**Committee of Experts on the Transport of Dangerous Goods
and on the Globally Harmonized System of Classification
and Labelling of Chemicals**

**Use of the Manual of Tests and Criteria in the context of the
GHS**

**Transmitted by the Chairman of the Working Group on Explosives of
the Sub-Committee of Experts on the Transport of Dangerous Goods
(TDG Sub-Committee) on behalf of the Working Group**

1. Document ST/SG/AC.10/C.3/2018/88–ST/SG/AC.10/C.4/2018/26 contains the list of amendments to section 28 of the Manual of Tests and Criteria to include the determination of the SAPT, recommended for adoption by the TDG and GHS sub-committees.
2. This document contains the text of Part II section 28 of the sixth revised edition of the Manual of Tests and Criteria, as amended by ST/SG/AC.10/C.3/2018/88–ST/SG/AC.10/C.4/2018/26. All the proposed amendments are indicated: inserted text is shown in blue (**inserted**); deleted text is shown in red, strikethrough (**deleted**).

Figure 28.4.2.2: EXAMPLE OF DETERMINATION OF SADT OR SAPT

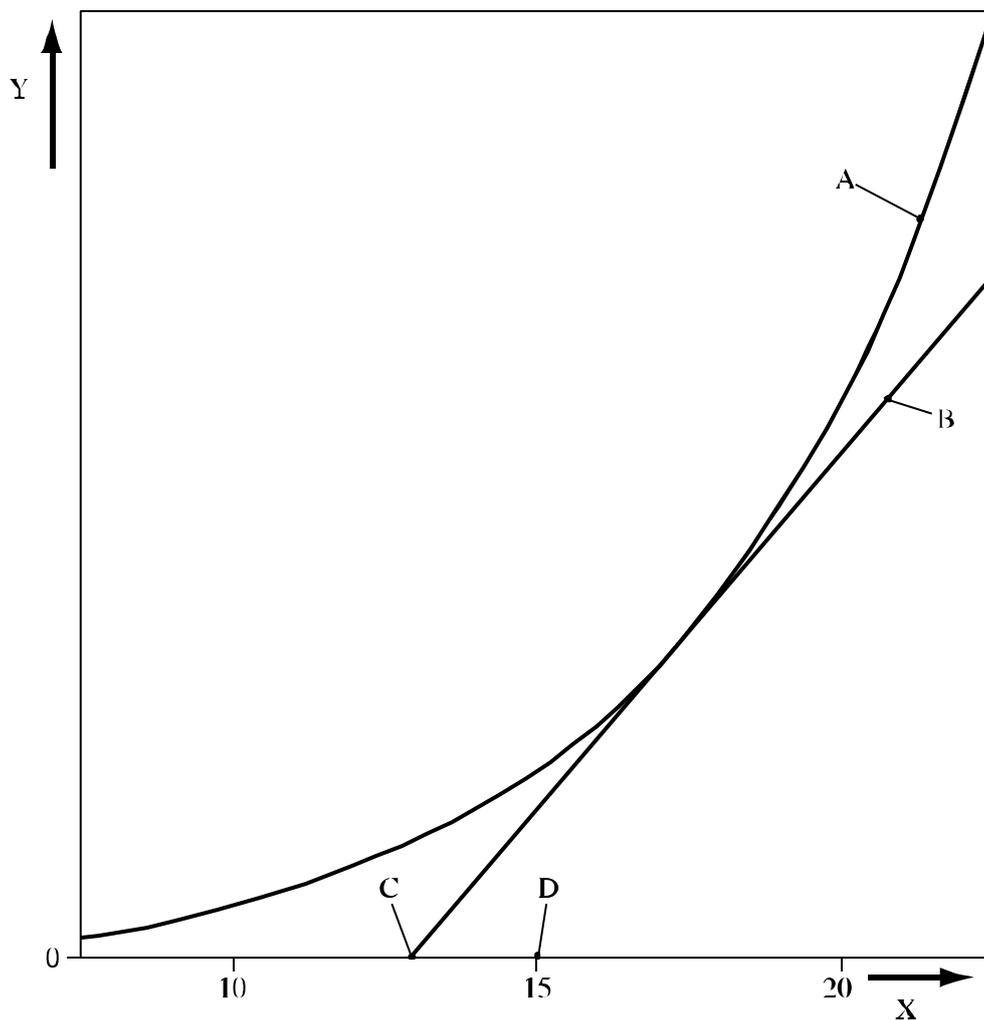
- (A) Heat generation curve
- (B) Line with gradient equal to the rate of heat loss and tangential to the heat generation curve
- (C) Critical ambient temperature (intercept of heat loss line with the abscissa)
- (D) ~~Self-accelerating decomposition temperature (SADT or SAPT)~~ - critical ambient temperature rounded up to next higher multiple of 5 °C
- (X) Temperature
- (Y) Heat flow (generation or loss) per unit mass

Figure 28.4.3.2: EXAMPLE OF DETERMINATION OF SADT OR SAPT

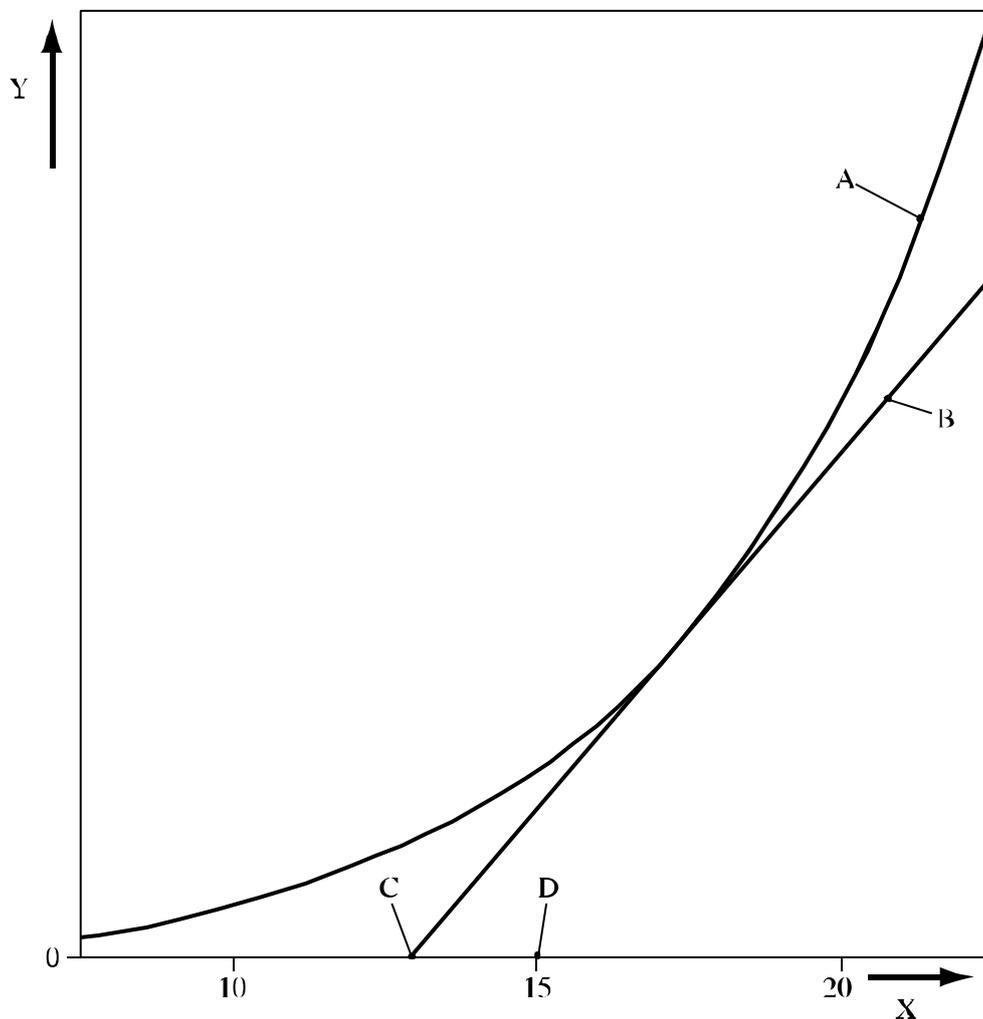
-
- (A) Heat generation curve
 - (B) Line with gradient equal to the rate of heat loss and tangential to the heat generation curve
 - (C) Critical ambient temperature (intercept of heat loss line with the abscissa)
 - (D) ~~Self accelerating decomposition temperature (SADT or SAPT)~~ - critical ambient temperature rounded up to next higher multiple of 5 °C
 - (X) Temperature
 - (Y) Heat flow (generation or loss) per unit mass
-
